Springbank Off-stream Reservoir Project

Response to CEAA Information Request Package 3 August 31, 2018

May 2019

Alberta Transportation

EIS Volume 1, Section 3.2, Figure 3-1

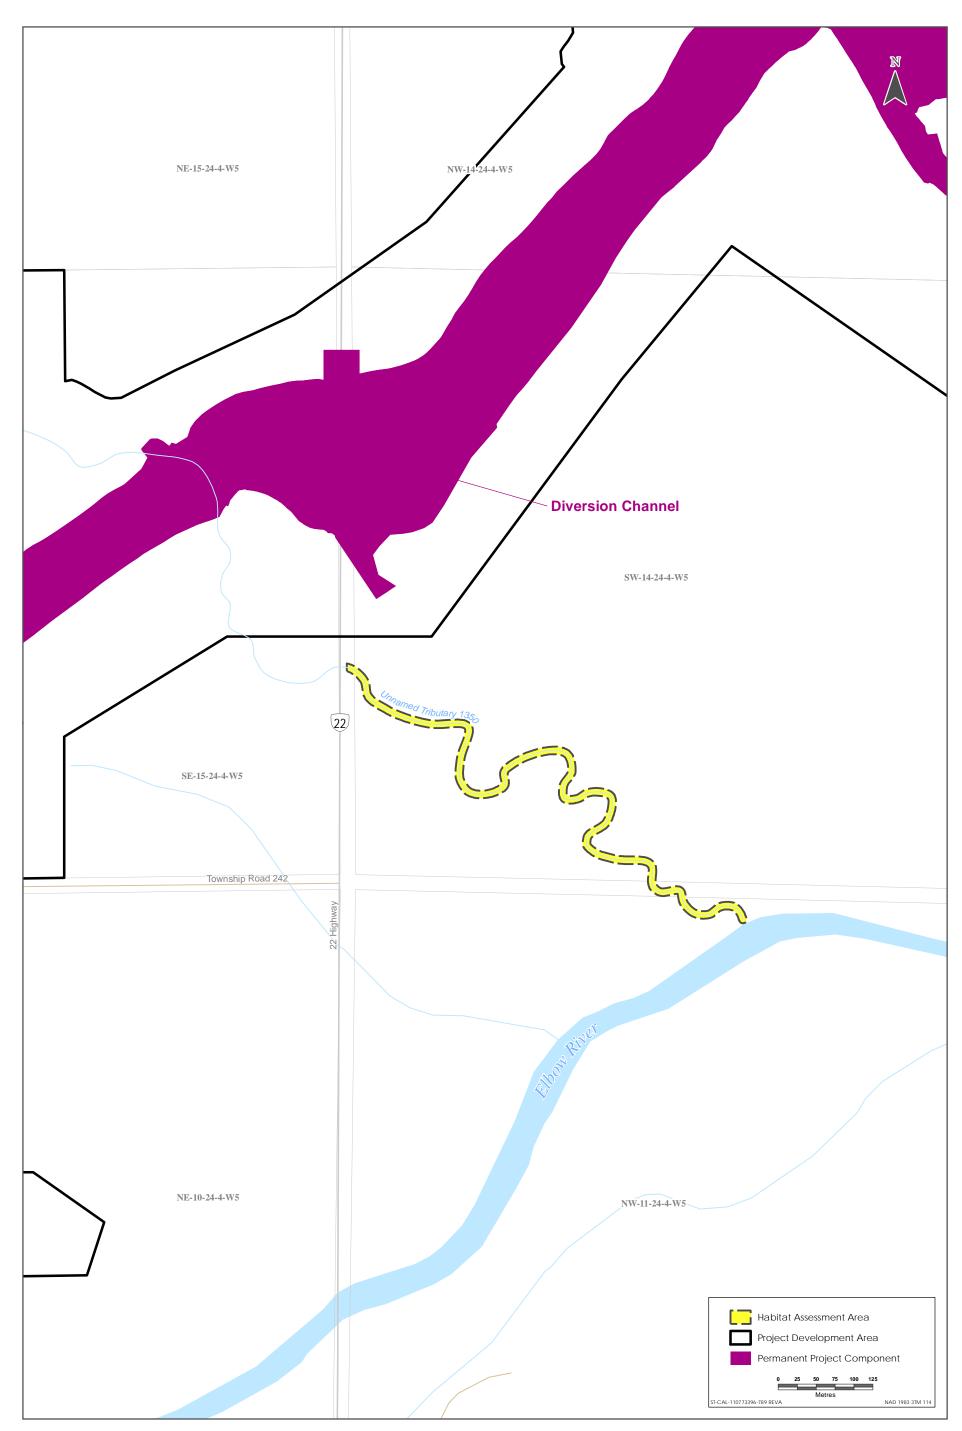
The EIS states that the LAA contains several tributaries to the Elbow River that contribute flow from the plains. The tributaries inside the reservoir area will drain through the low level outlet. The EIS describes and depicts a tributary that crosses Highway 22 near Township Road 242; however, no information is provided about the tributary between the proposed new bridges shown in Figure 3-1.

- a) Clarify the disposition of the unnamed tributary that currently crosses Highway 22 near Township Road 242 before joining the Elbow River.
- b) Describe the project interactions and effects of any changes to the unnamed tributary on VCs.

a) The unnamed tributary (Tributary 1350) is located on legal land sections NW-11-24-W5M and SW 14-24-24-W5M (see Figure IR7-1). The field data sheet for the tributary is provided in Appendix IR7-1.

Figure IR11-3

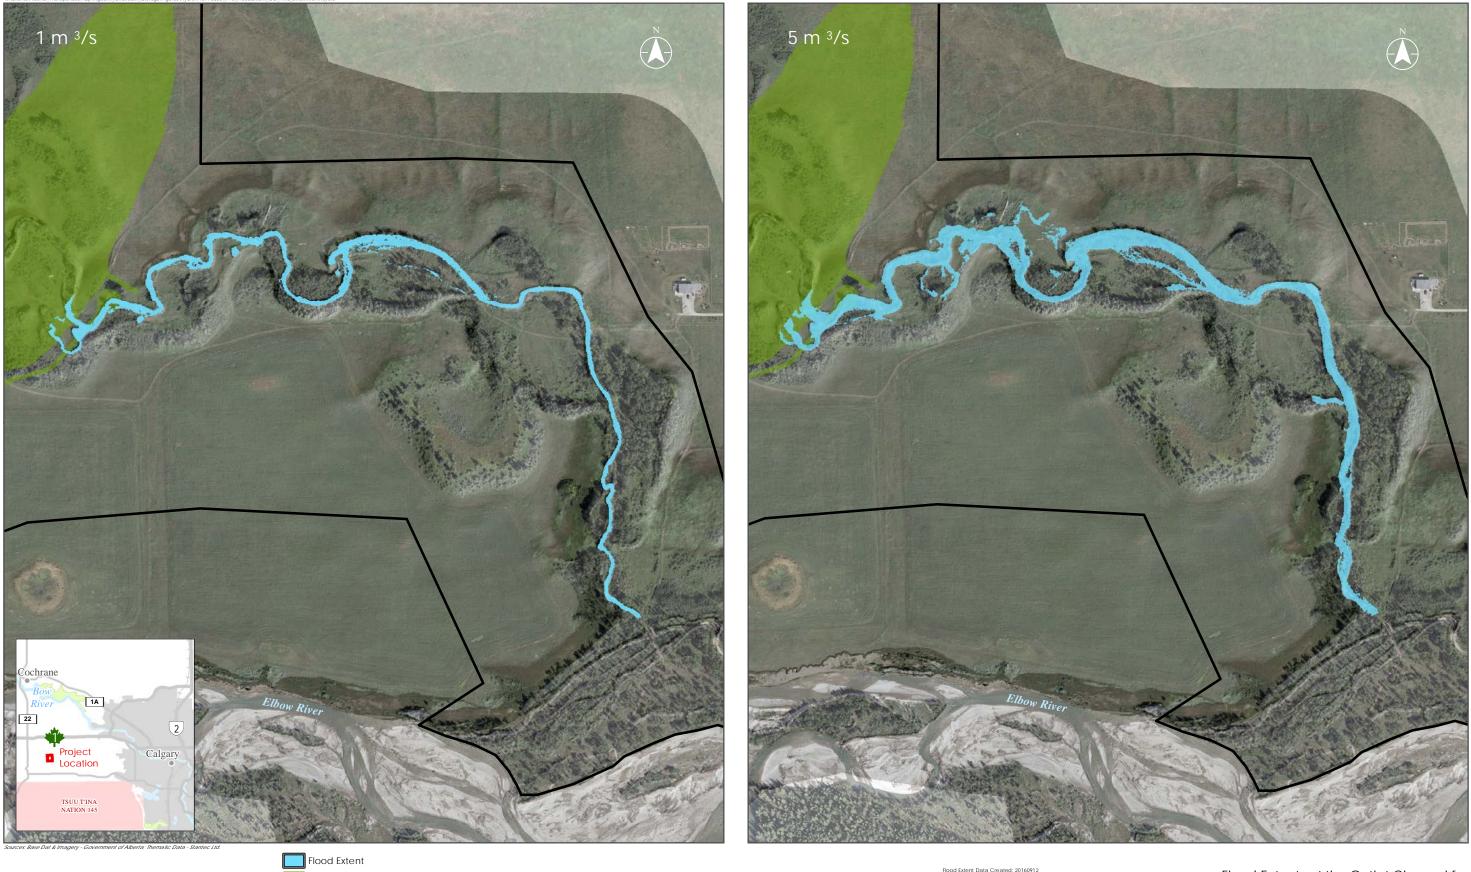
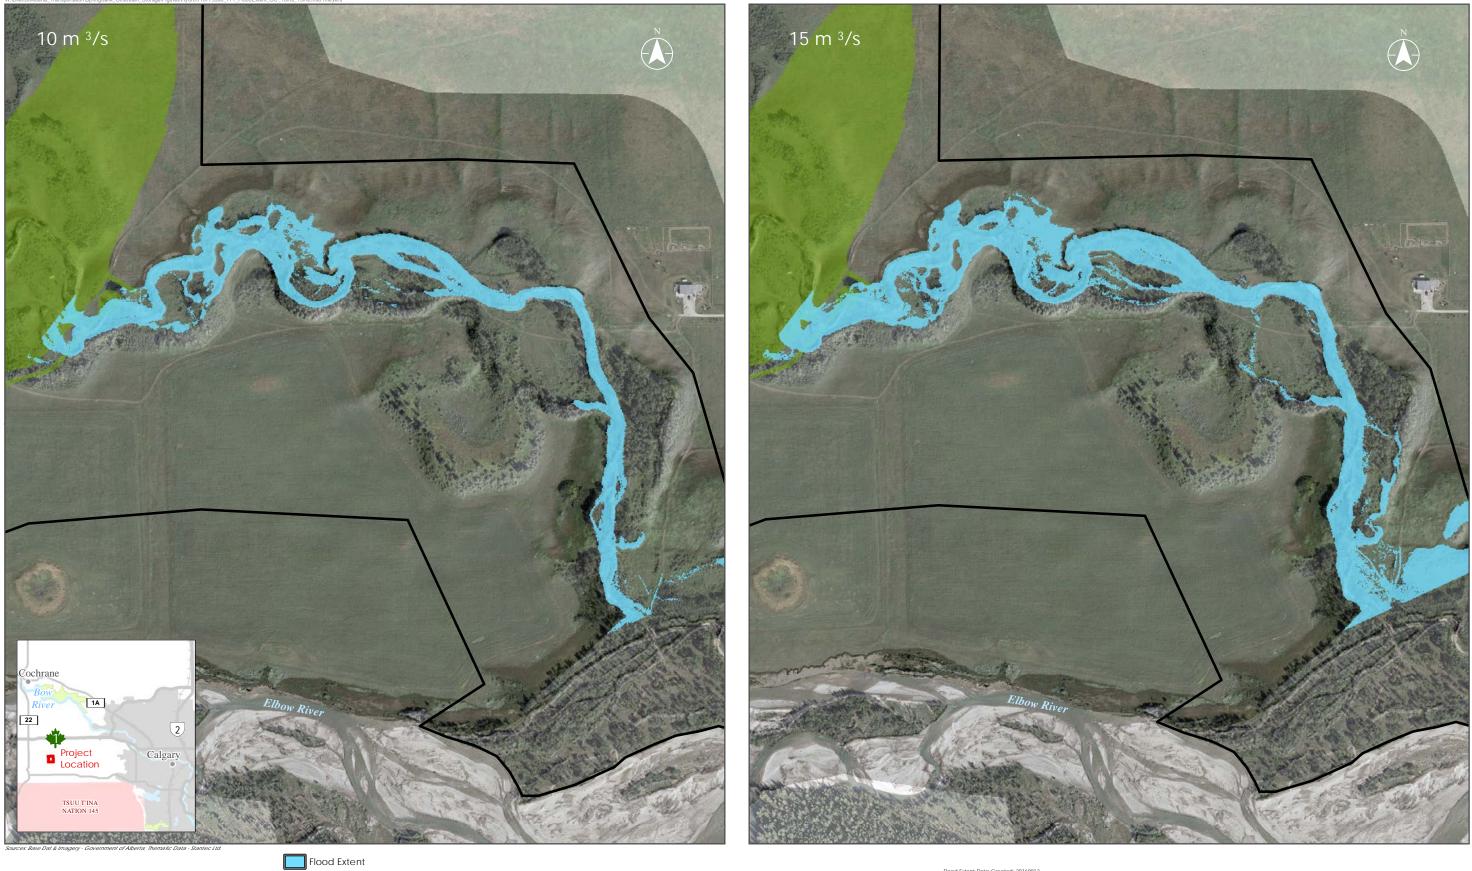
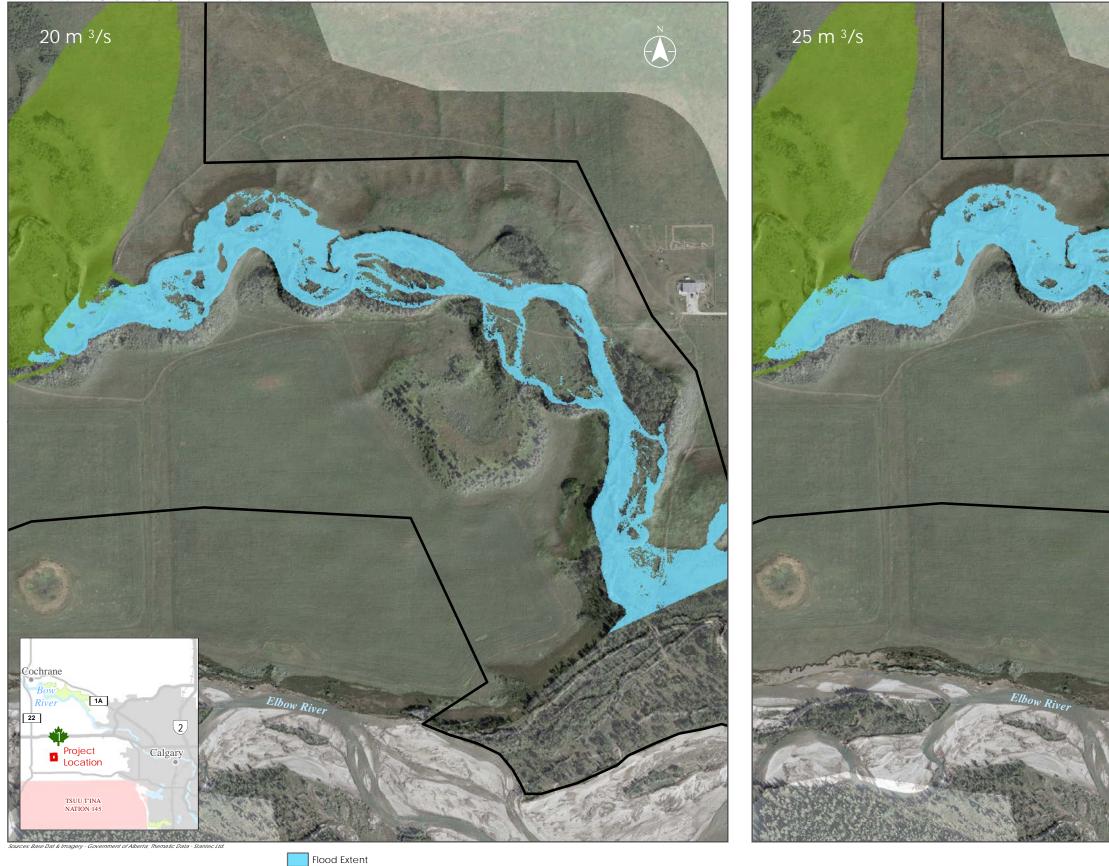
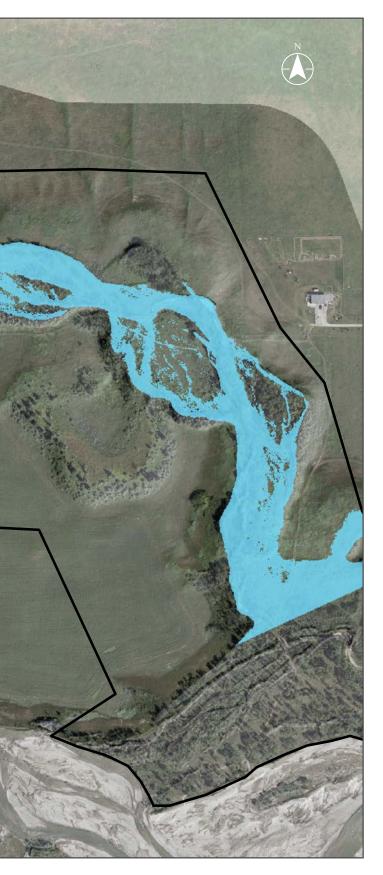
By contrast, maintenance of the unnamed creek (low-level outlet channel), following the release of water from the reservoir after a flood, would be more limited. The existing creek channel is undersized for the expected design flood discharge; therefore, within this section there could be erosion of the beds and shores. However, the existing channel is nested within a larger floodplain valley that is vegetated with forest and shrub. Overbank flows within the floodplain has lower shear stress and erosive power as shown in Figures IR11-1 to IR11-3. Root mass from the vegetation may provide erosion protection within the floodplain area. Maintenance may be provided by smaller equipment that can access the stream banks without wide-scale vegetation removal. This will reduce impacts to the creek.

The net change in aggradation and degradation for the unnamed creek and for Elbow River (from the location of the diversion inlet to Glenmore Reservoir) for each flood is summarized in the response to IR3-09, Table 9-1. The net change in aggradation and degradation in the unnamed creek suggests that the geomorphological effect would be similar for both the design and 1:100 year flood. Although a higher release rate and volume is associated with the design flood, most of this flow would be overbank and not in the active channel. As a result, the actual flows contained in the unnamed creek would be at bankfull for the same period for the design flood and 1:100 year flood, hence the similarity in net change. For the 1:10 year flood release, there is a much lower net change. The net change in aggradation and degradation in the unnamed creek suggests that the geomorphological effect would be similar for both the design and 1:100 year floods. Although a higher release rate and volume is associated with the design flood, most of this flow would be overbank and not in the unnamed creek. Given that the floodplain is heavily vegetated with high roughness values, the reduction is a result of less than bankfull flow reducing degradation/aggradation during release.

- c) Proposed maintenance measures for the unnamed creek following a flood may include a variety of bank stabilization and vegetation restoration strategies, such as:
  - bank grading that reduces the steepness of channel slopes
  - bio-engineered bank stabilization with erosion blankets and live branch layering
  - rock toe and bank armouring
  - grade control riffle or rock structure

# Figure IR13-2 Physical Model Mobile Bed Cumulative Change at the 1/16 Model Scale

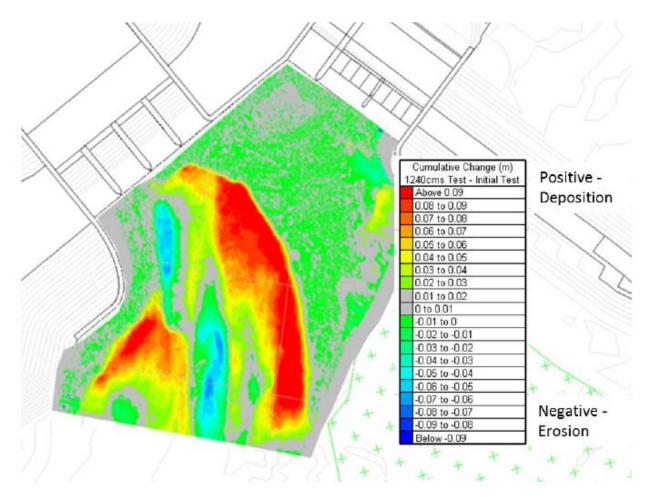
During the simulations, most of the bed sediment remained upstream of the diversion structure. Small quantities of bedload sediment that passed through the modelled diversion inlet deposited immediately downstream of the chute blocks. In summary, sediment is predicted to deposit upstream of the gates and in the pattern shown in Figure IR13-2 (i.e., the cumulative change in bed geometry after all simulations).

Figure IR13-3 Diversion Structure 2D Model Domain

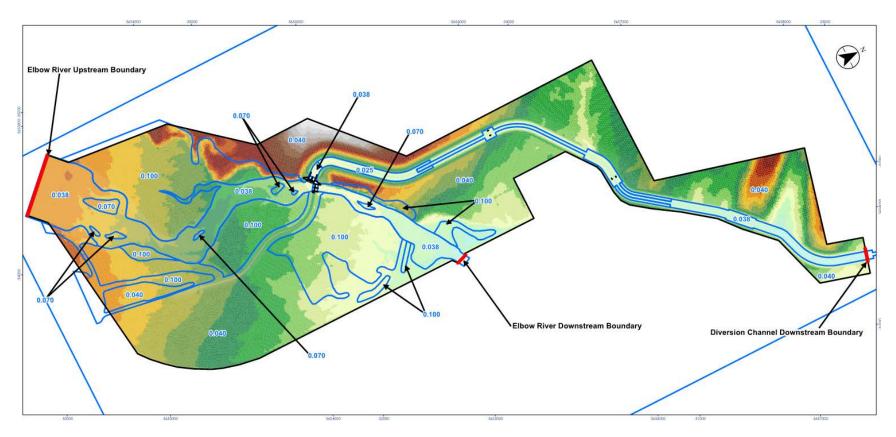
Figure IR13-3 displays the model domain that includes portions of Elbow River, diversion structure, and the diversion channel. The downstream boundary of the diversion channel is at the entrance to the off-stream reservoir.

# Figure IR13-5 Sediment Loading Simulation

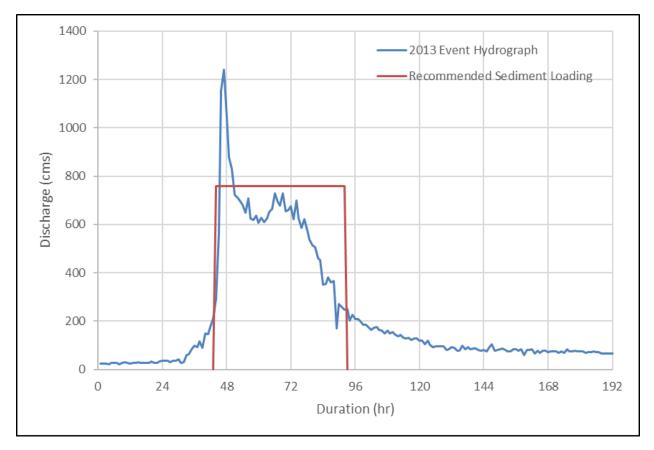
The model was run for a total duration of seven days. The desired duration of sediment loading at the diversion structure is two days (as illustrated by the red box in Figure IR13-5); however, three days is required for the modelled sediment-load to travel from the upstream boundary of the model to the diversion structure because it represents a state of dynamic equilibrium in between. This means that the "true" sediment loading period occurs from Day 3 to Day 5 of the simulation. An additional two days were added to evaluate continued performance beyond the two-day duration.

Figure IR25-1

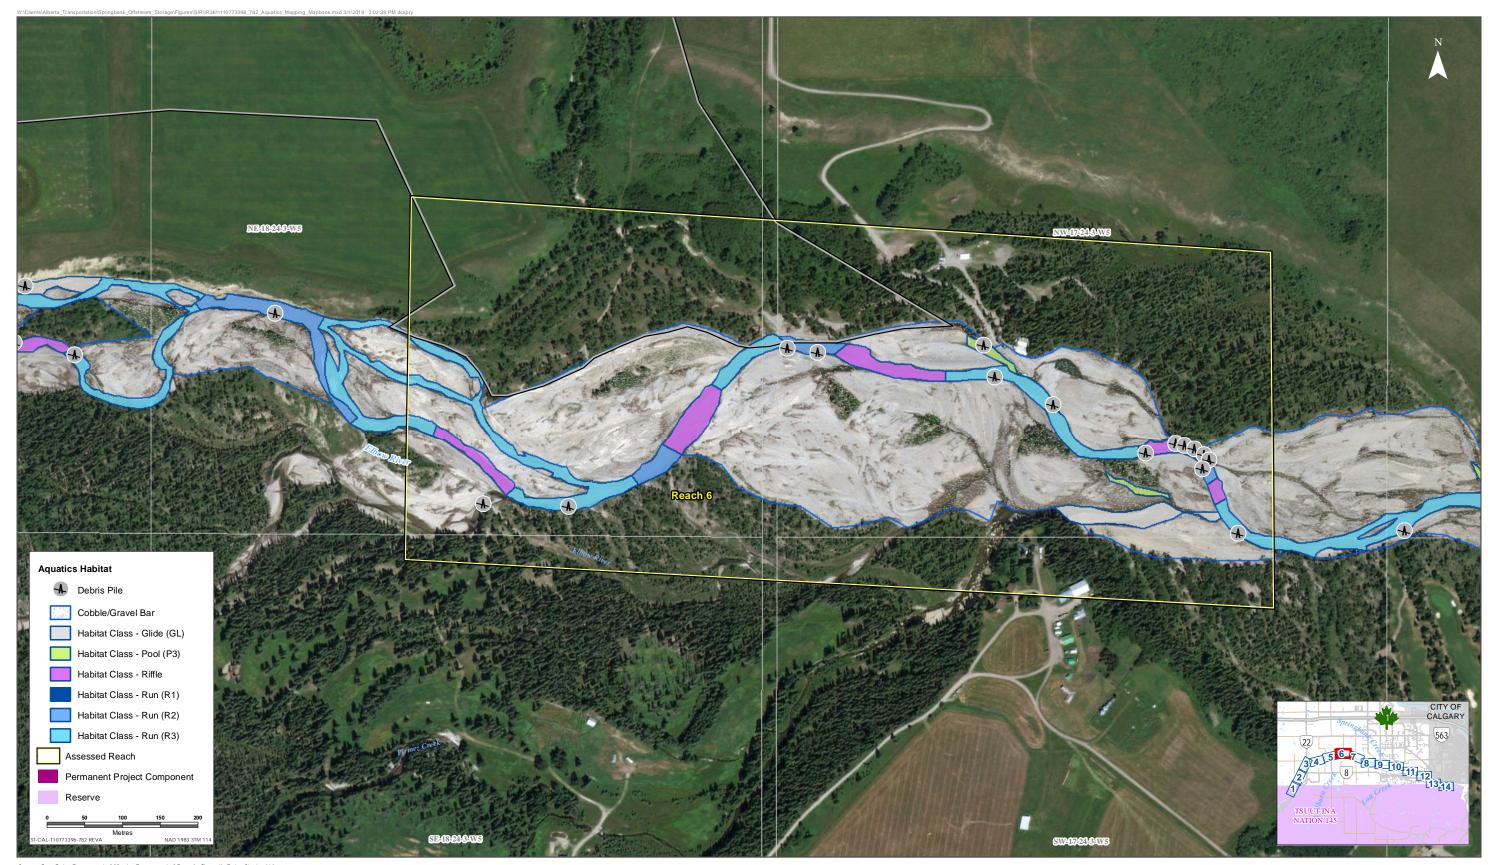
- a) For all areas already mapped, provide a map of fish habitat that is consistent with the definition of fish habitat provided in the EIS and the requirements in the EIS Guidelines.
- b) Provide a Fish Habitat Map for the Elbow River at the low level outlet channel, consistent with the requirements in the EIS Guidelines.
- c) Clarify whether Table 8-5 is meant to correspond with Figure 8.2-2, and explain the differences between the information provided.

- b) Habitat mapping in the unnamed creek channel is in Figure IR25-1, Reach 6 of the mapbook provided in a. However, the imagery showed the channel as dry, so there are no habitat units shown (only visible water was mapped for the desktop review).
- c) Volume 3A, Section 8, Figure 8.2-2 (duplicated here as Figure IR25-2) identifies the habitat units noted at the location of the diversion structure. The habitat described in the figure provides an overview of habitat types that some fisheries species in the Elbow River tend to utilize to spawn, rear, and overwinter. While some of those habitats may be present in Figure IR25-2, the life processes described in Volume 3A, Section 8.2.2, Table 8-5 (duplicated here as Table IR25-1) have the potential to occur in these areas but were not confirmed during field assessments conducted in 2016.
